59-61 Camden High Street - 2023/4561/P

Photos and Plans for 2023/4561/P – 59-61 Camden High Street, NW1 7JL

Delegated Report		Analysis sheet	Expiry Date:	19/12/2023
(Members' Briefing)		N/A / attached	Consultation Expiry Date:	07/01/2024
Officer			Application Number(s)	
Sam FitzPatrick			2023/4561/P	
Application Address			Drawing Numbers	
59-61 Camden High Street London NW1 7JL			Please refer to decision notice.	
PO 3/4	Area Team Signature	C&UD	Authorised Officer Signature	
Proposal(s)				
Conversion of property from 4 flats (3 x 2 bedroom flats and 1 x 1 bedroom flat) to 8 flats (2 x 2 bedroom flats, and 6 x 1 bedroom flats). Erection of front mansard roof extension above existing second floor and erection of second floor rear extension. Creation of roof terraces to rear first and second floors, along with associated external works.				
Recommendation(s):	Grant Conditional Planning Permission Subject to a Section 106 Agreement			
Application Type:	Full Planning Permission

7. Existing side elevation (left) and proposed side elevation (right)

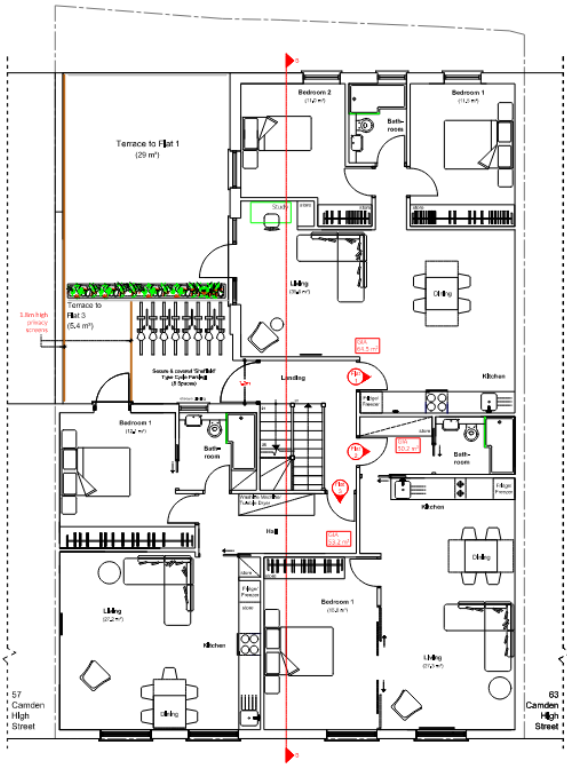
- 6.3. Although the proposed front mansard roof differs from the existing roofscape, the roof form has already been altered and is not intact. Given that the design of the mansard is also a little set back from the front elevation and maintains the parapet line, as well as matching the height of neighbouring properties, the proposed front mansard is acceptable. Details of the mansard roof cladding in natural slate would be secured via a condition attached to this decision, as well as details of the windows and any balustrading.

- 6.4. The mass and scale of the front mansard is appropriate for the site and its context. The reinstatement of the butterfly parapet wall and roof profile in a historically accurate position is supported and will soften the impact of the increased mass from the front mansard, allowing it to integrate better with the roof form. This was a key reason that the appeal for the previous iteration of this development (APP/X5210/W/21/3280049) was dismissed, as the bulk and scale of the mansard to the rear would constitute a dominant addition to the building and result in the loss of the distinctive butterfly roof formation. The amended design is considered to be a modest and respectful addition that preserves the butterfly roof, and so can be said to preserve the local character, including the buildings and features that make a positive contribution to it.

9. Proposed first, second, and third floor plans and roof plan

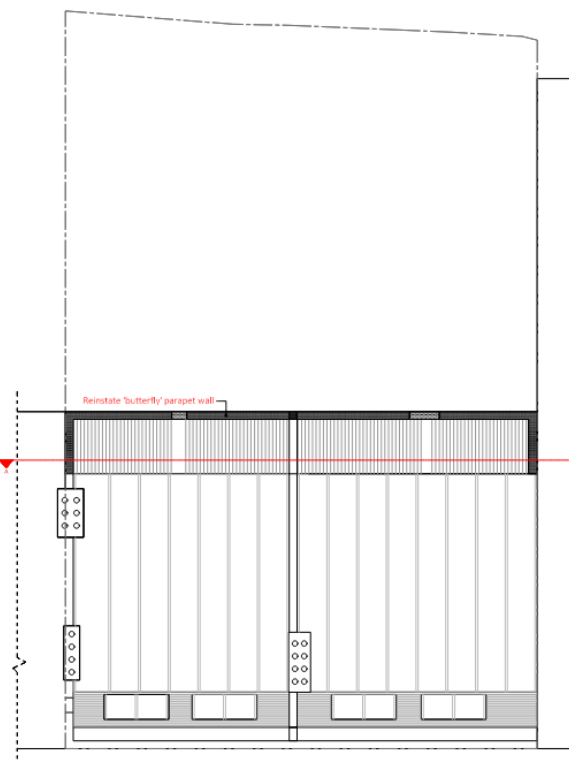
- 2.1. During the process of the application, the proposal was amended following officer comments in order to reposition the roof terrace at the second floor level. This was because the original design featured the roof terrace to the side of the extension rather than the rear, which provided direct views into the windows of occupiers, including other flats within the host building as well as neighbouring buildings. The proposal has also been amended to add a privacy screen to the side of the larger roof terrace at first floor level that serves flat 1. The new position of the second floor terrace and new privacy screens would provide limited opportunities for overlooking and so are acceptable, as detailed in section 11 of this report.

11.4. It is noted that there were a number of objections relating to the potential for overlooking from the new units and their associated roof terraces into neighbouring properties. It is considered that there could be overlooking of the neighbouring windows at 57 Camden High Street from the rear roof terraces, so privacy screens are proposed along the boundary in order to alleviate overlooking concerns. These would be located along the boundary between no.57 and no.59, as well as between the terraces for flat 3 and flat 1 and the bike storage area. This would also prevent overlooking between the two roof terraces. The details of the privacy screening would be secured by condition. An additional condition would also be included to ensure that the flat roof of the rear extension is not used as a terrace. The design of the rear extension was also revised so that the roof terrace associated with flat 6 was located to the rear of the return, rather than the side. If located at the side of the return, the terrace would have the potential to create opportunities for overlooking into neighbouring properties and units that are part of the main building, however when located to the rear there would be no such opportunities for overlooking created. As such, the revised design would now be acceptable.

- 6 1.8 metre high screens, details of which shall have been submitted to and approved in writing by the local planning authority, shall be erected between the proposed roof terraces and the cycle parking area, as well as between no.59 and no.57, as shown in drawing ref. CHR/23/P/03/C. These should be erected prior to commencement of use of any of the roof terraces and shall be permanently retained. Similarly, details of the screening and planting between the terraces of Flat 1 and Flat 3 shall be submitted to and approved in writing by the local planning authority prior to commencement of use of any roof terrace and shall be retained permanently thereafter.
